AC-26-10

SP-2026-00064 (Appeal)
SIGN-2025-00303 (Building Safety – Sign Permit)

Subject: AC-26-10, SIGN-2025-00303: Lindmark Companies ("Applicant") appeals the Planning staff's decision to DENY a sign permit for a billboard conversion to a digital billboard for the property located at 524 Montano Rd NW, zoned MX-M.

Lindmark Companies
Digital Conversion
524 Montano Rd NW
10'x30' Tri-vision Three (3) Faces
James Spence
940.867.1467

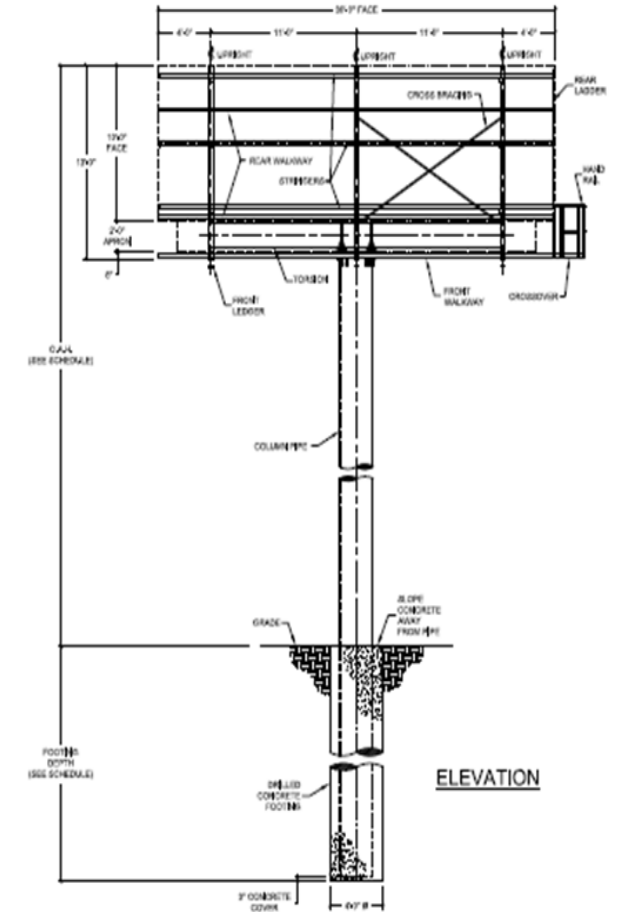
Zoning - Cap and Replace Off-Premise Sign Removal Application is incorrect in citing the existing sign in the same location towards the removal credit. For a sign to be counted as “removed advertising space,” it must be removed and not replaced, as per IDO 5-12(H)(3)(b)(4). Both the sign and its support structure must be permanently removed, as per IDO 5-12(H)(3)(b)(2). JPalmer
